# 10 Mb/s Single Twisted Pair Ethernet 10BASE-T1L Changes

Steffen Graber  
Pepperl+Fuchs

# PCS Receive State Diagram Changes

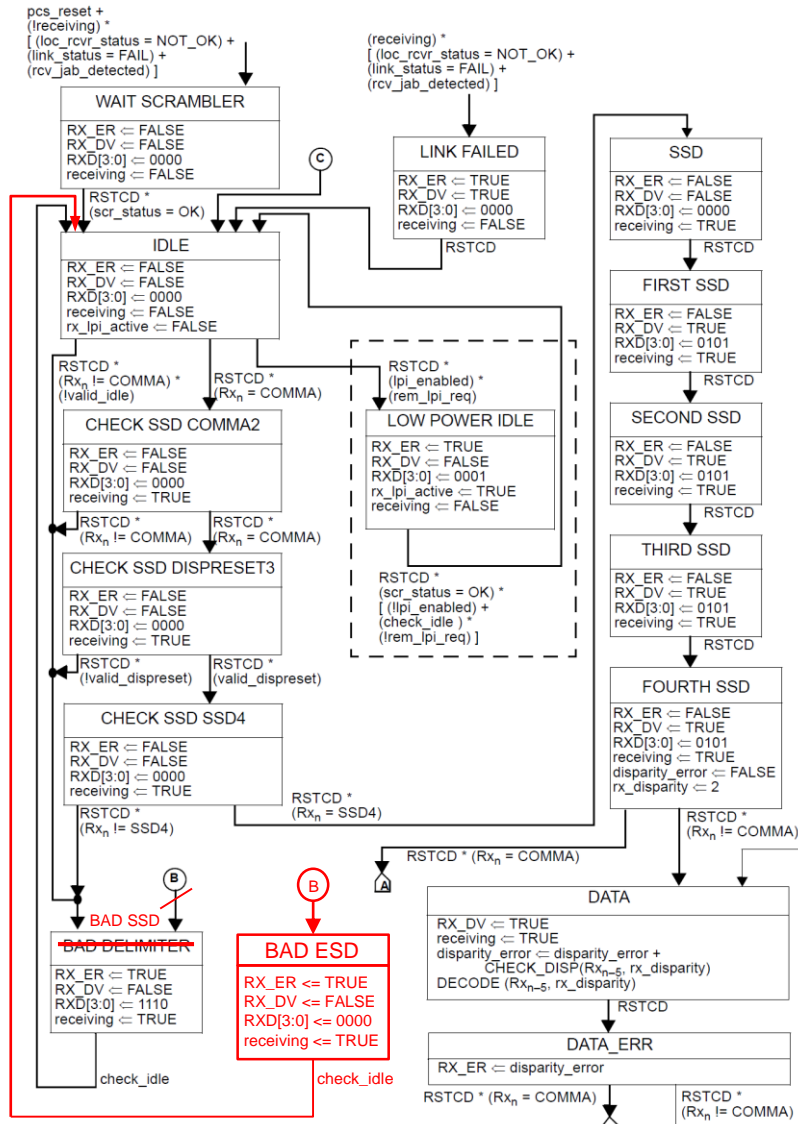
- Currently reception of a bad SSD as well as a bad ESD both ends up in BAD DELIMITER state.
- Within this state a False Carrier Indication is signaled over the MII.
- A False Carrier Indication in other IEEE802.3 clauses is only provided when receiving a bad SSD encoding, not a bad ESD encoding.
- Thus the BAD DELIMITER state needs to be splitted into two separate states: BAD SSD, which is executed when receiving a bad SSD and thus providing a False Carrier Indication over the MII and BAD ESD, which is executed when receiving a bad ESD and thus not providing a False Carrier Indication over the MII.
